**XEROX BUILDING 801
HENRIETTA, NEW YORK**

**REMEDIAL INVESTIGATION AND FEASIBILITY STUDY
WORK PLAN
ADDENDUM**

MAY 15 1992

FIGURE 3.1

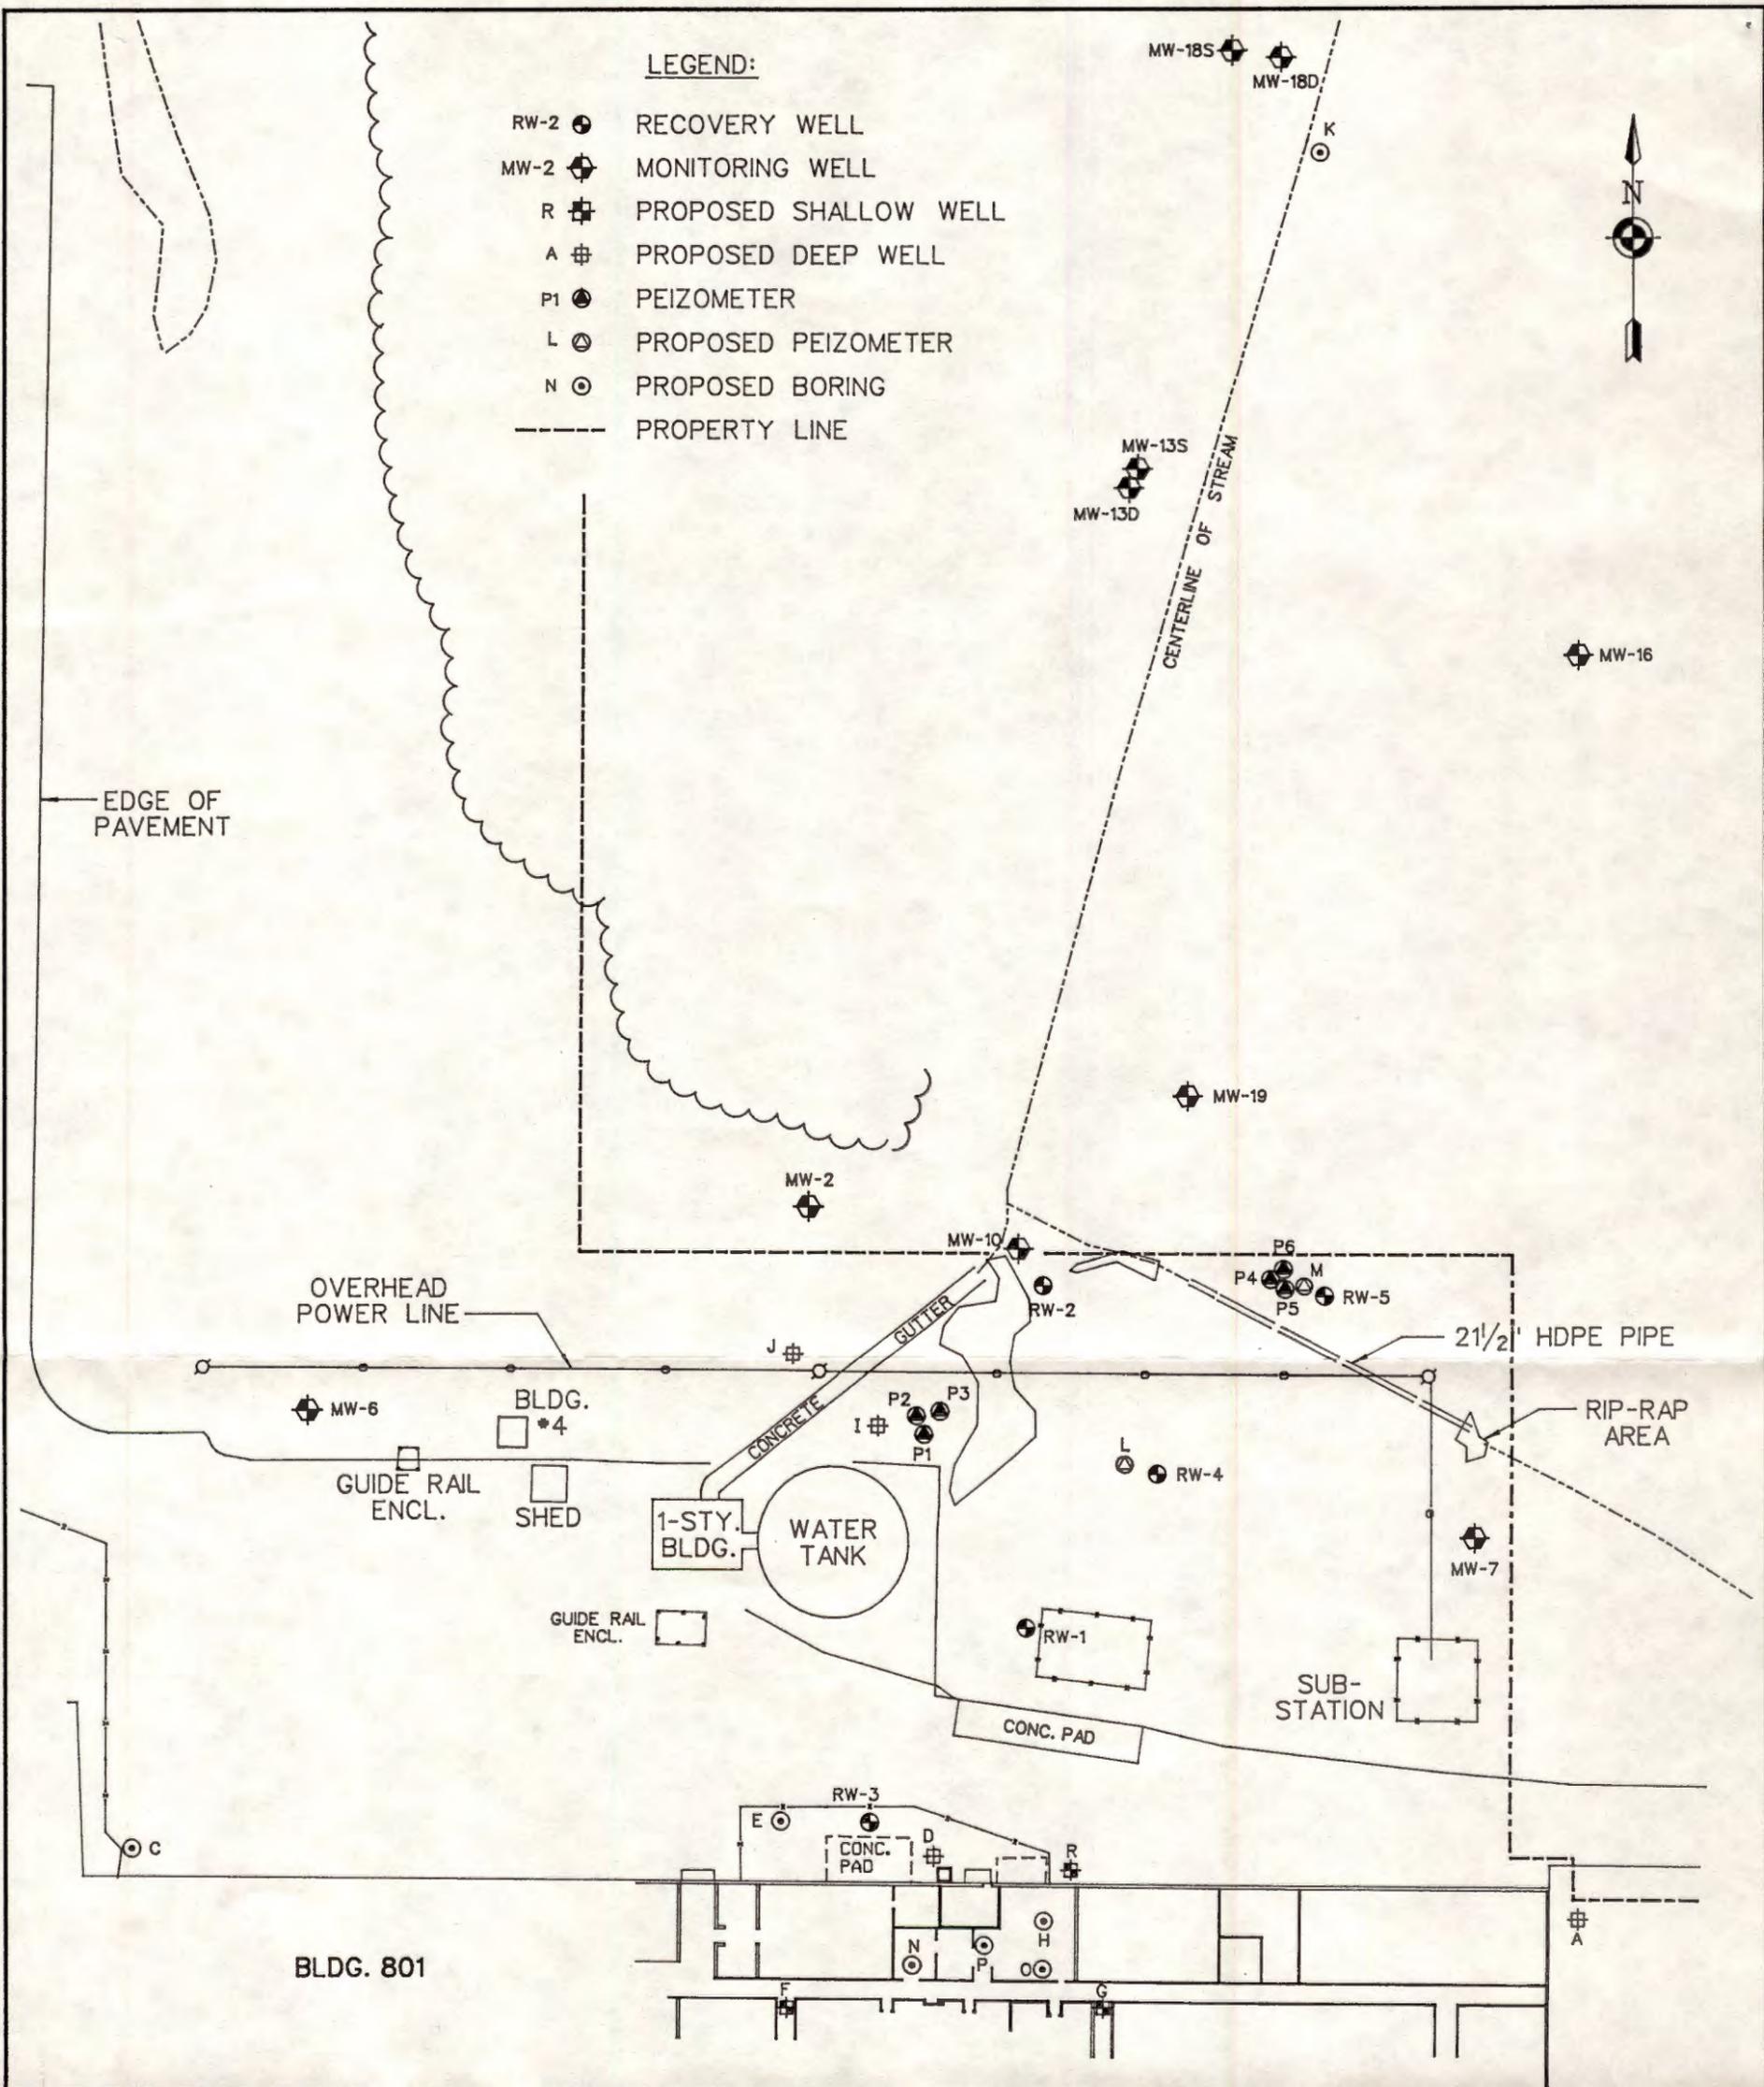
It should be noted that in this work plan, letters have been used to temporarily identify individual boring locations. The locations are shown on Figures 3.1 and 3.2. Upon completion, each boring or monitoring well will be assigned a sequential number based upon the order in which it was completed. This is intended to eliminate possible confusion if modification or expansion of either phase of the program is necessary.

Deep borings (i.e. those drilled through the clay confining layer) located in the source area will require the use of non-conventional drilling techniques. At present only one boring (D on Figure 3.1) of this type is proposed. To complete this boring conventional hollow stem auger and split spoon sampling techniques will be utilized above the confining clay layer. This drilling will be performed using 6-1/2-inch I.D. augers. When the clay layer is reached, the augers will be carefully withdrawn to minimize caving. A 9-inch diameter steel casing will then be set in the clay and the annulus grouted using cement/bentonite grout. When the grout has set, 4-1/4-inch hollow-stem augers will be used to continue drilling through the center of the steel casing. The boring will be continued to the bedrock interface, an anticipated depth of approximately 40 feet. A 2-inch I.D., deep observation well will then be installed in accordance with the methodology described in the following section. Based on the drilling conditions encountered, it may be necessary to complete the lower portion of the boring using 2-1/2-inch I.D. augers. This would require a reduction in the well diameter to 1.0 inches.

Phase I of the drilling program involves the installation of 13 borings. The boring locations are shown on Figures 3.1 and 3.2. The purpose and specifications for each are presented below and summarized in Table 3.2.

FIGURE 3.2

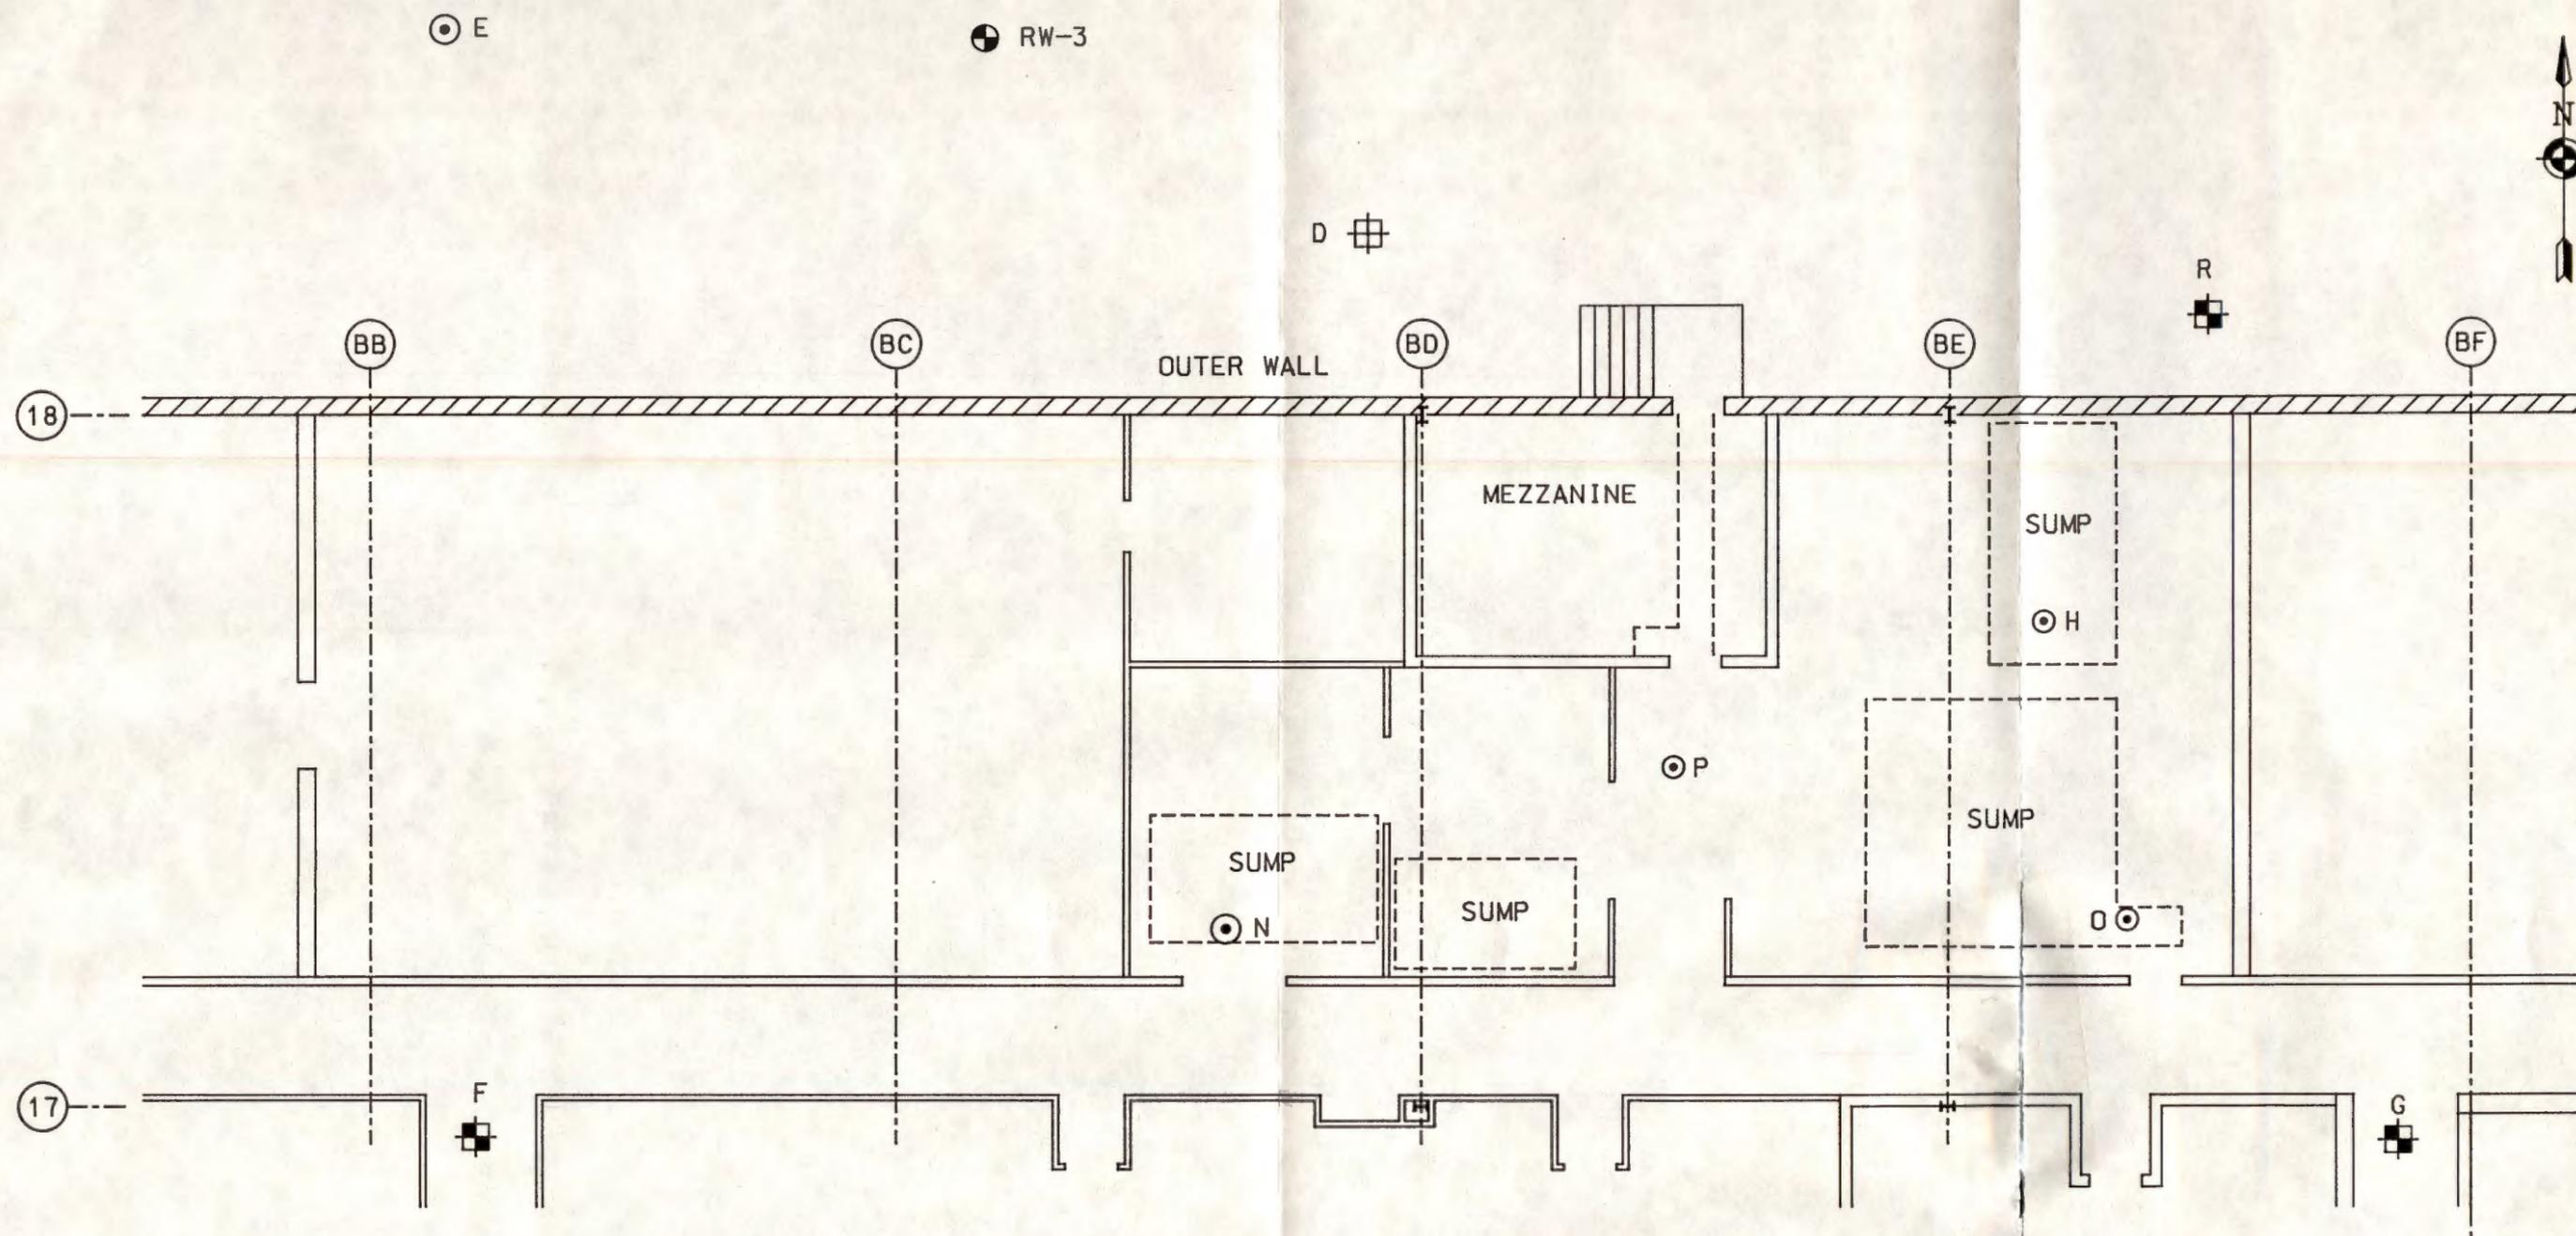
Borings D, E, F, G and H will be installed in and around the suspected source area and are primarily intended to provide chemical information. Borings D and E will be located immediately outside and north of Building 801 as shown in Figure 3.2. Boring D will penetrate to a depth of approximately 40 feet. Since this boring is situated in approximately the center of the plume and will penetrate through the clay confining layer, the non-conventional drilling method described in Section 3.2.1 will be used. This boring will continue to a depth of approximately 40 feet and an observation well, screened in the lower aquifer, will be installed. The well will be completed using the procedure as described in Section 3.4.2.2.

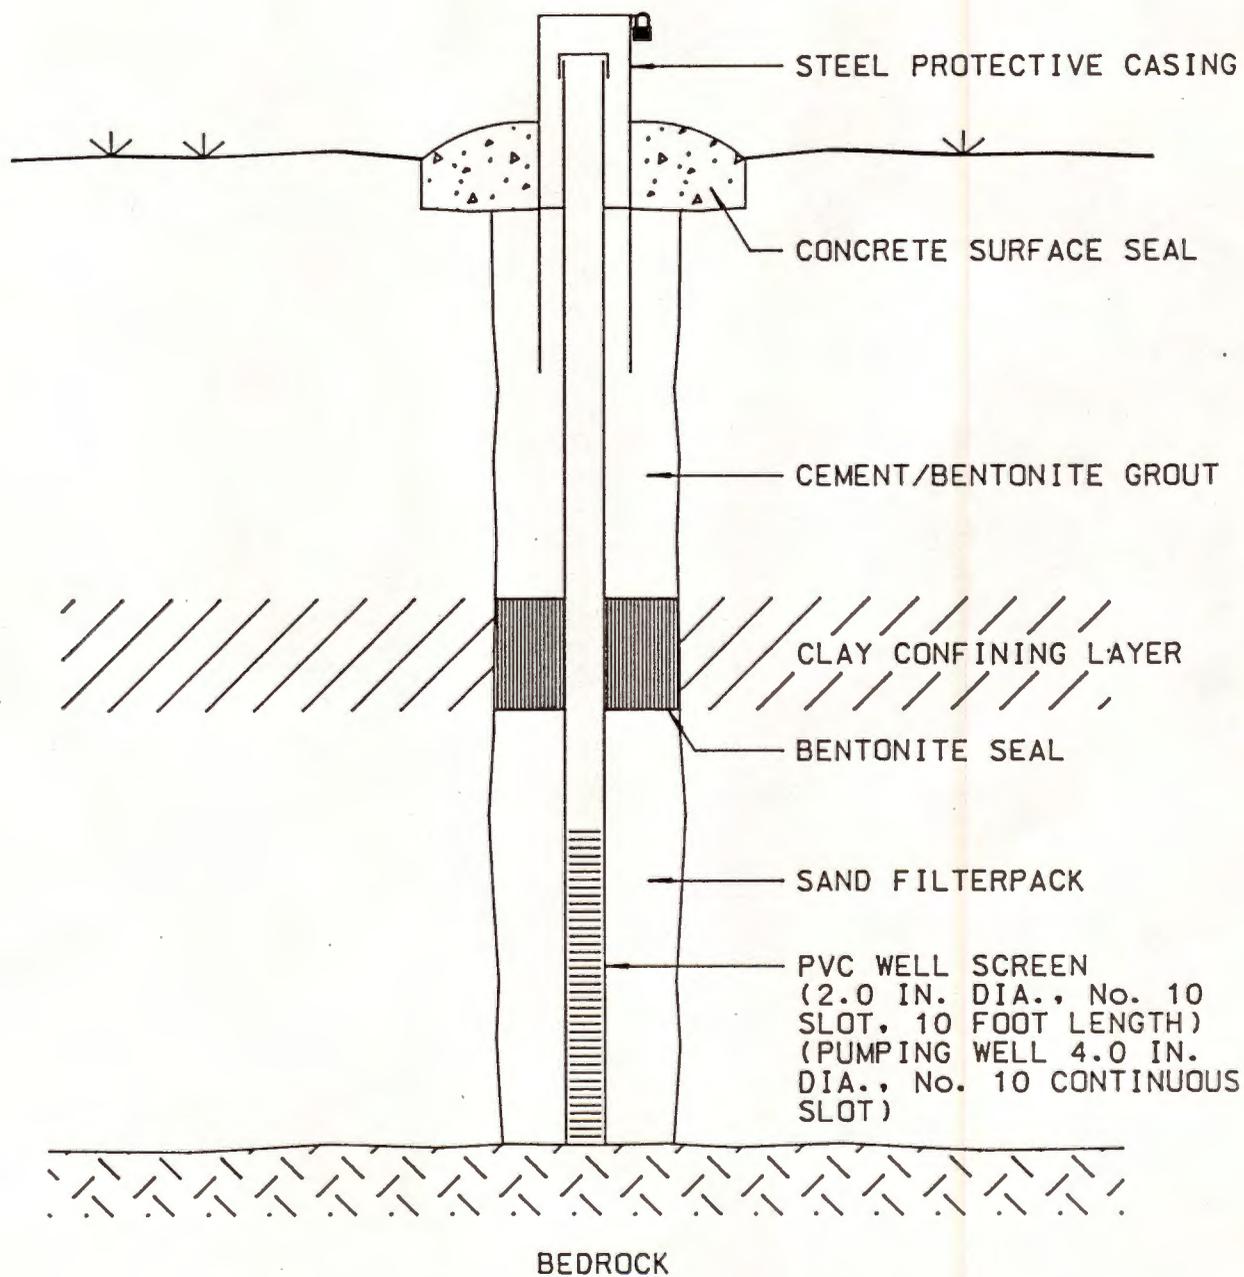
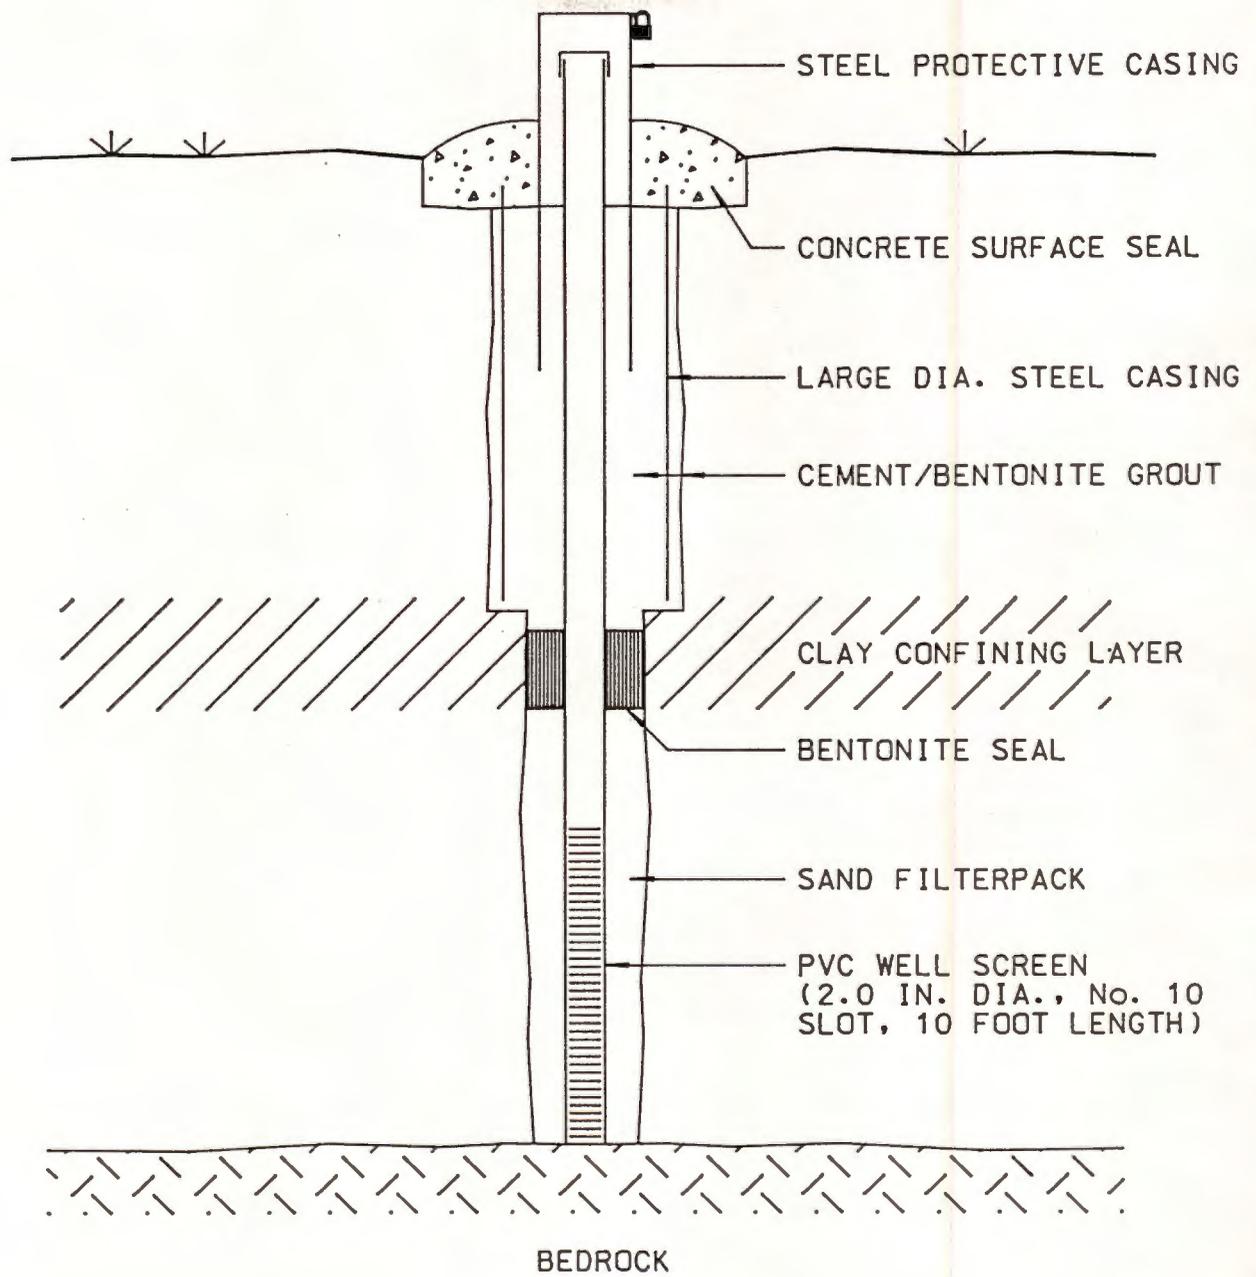
Deep wells proposed for the site include one (1) pumping well and five (5) observation wells. The pumping well will be constructed using approximately 10 feet of 4-inch diameter No. 10, continuous slot, PVC screen and the appropriate length of riser. The observation wells will be constructed using 10 feet of 2-inch diameter, No. 10 machine slot PVC screen and riser. All deep wells will be set with the bottom at the bedrock interface, a depth of approximately 40 feet. A sand pack of appropriate grain size and composition will be used to fill the well annulus up to approximately the base of the confining clay layer. A bentonite seal, no less than 3 feet thick, will be placed above the sand pack to ensure that the well is sealed within the clay layer. The remainder of the annulus will be backfilled with bentonite/cement grout and the well will be appropriately finished and protected at the surface. Proposed deep pumping and deep observation well construction details are illustrated in Figures 3.3 and 3.4.
